Delegated Report

Planning Application No: 20220727

Location: 17 - 19 Perry Street Northfleet Gravesend Kent

Description: Erection of first floor rear extension incorporating an external staircase to facilitate sub-division of first floor into 1 no. one bedroom flat and 1 no. one bedroom maisonette; erection of single storey infill rear extension to provide bathroom and flat entrance; erection of detached two storey triple garage with open pedestrian access and bin storage at ground floor with storage at first floor level

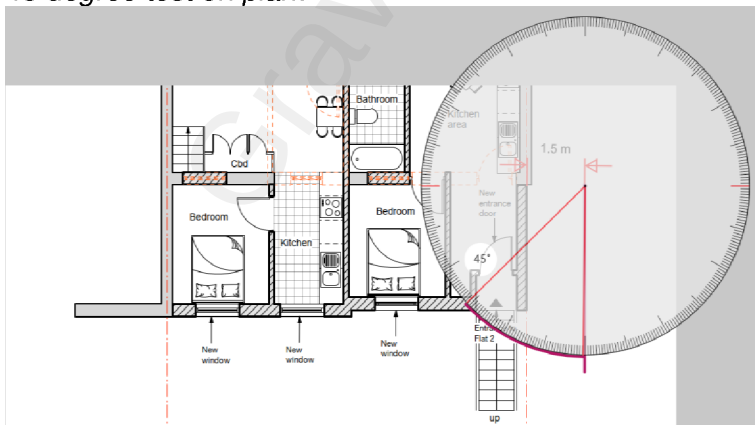
With respect of the proposed garage building, the rear elevation of the building would be 7.8m from the rear elevation of the host building. There would be no habitable accommodation in the garage but it is considered that at this proximity and the scale of the building, it would cause an overbearing and overly dominant effect on the occupiers of the two proposed flats which would have windows serving bedrooms and a kitchen in the rear elevation at first floor level.

45 degree test on elevation:

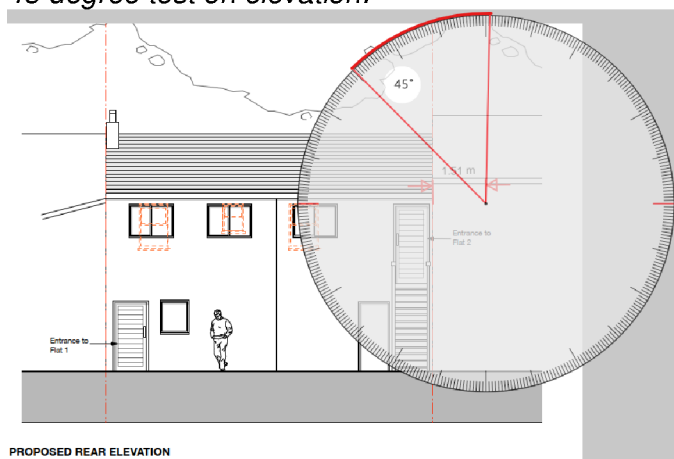
At the neighbouring building to the east no. 15 Perry Street, this building has no rear extensions. The first floor is in use as a flat and there are three windows in the rear elevation at first floor level. The nearest window appears to serve a toilet and is therefore non-habitable. It is unclear what the next window along serves but as this may be habitable the 45 degree test has been done from it as below, this shows that the proposed extension would not fail the 45 degree line from this window on either plan or elevation and therefore denotes that there would be no undue overshadowing or loss of light to this window:

There are no windows proposed in the east flank elevation of the proposed first floor extension and therefore no impact on no. 15 with regards overlooking.

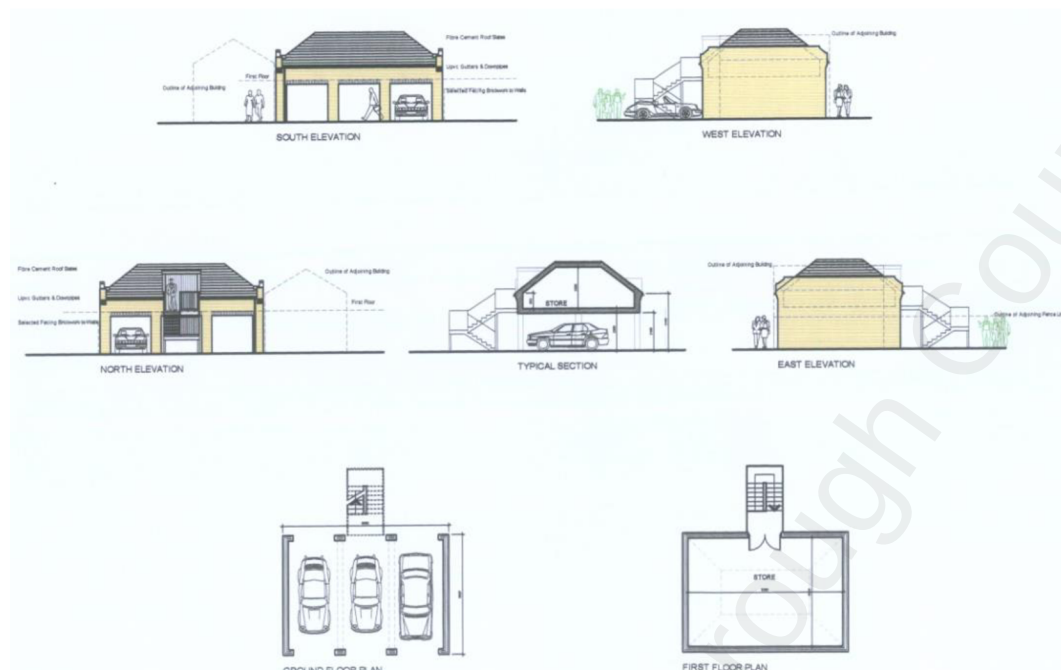
It is noted that planning permission was given for 'Erection of a detached two storey building to provide three covered parking spaces at ground floor level with storage over' in 2007 under ref. 20061013 as follows:

However, this was of a different scale and design from what is proposed in this application and with the pitched roof at least appeared to be of a more sympathetic design in that respect. Furthermore, the permission is expired and what permitted in 2007 which is prior to the current development plan. As such it is only considered to add limited weight to the proposal.
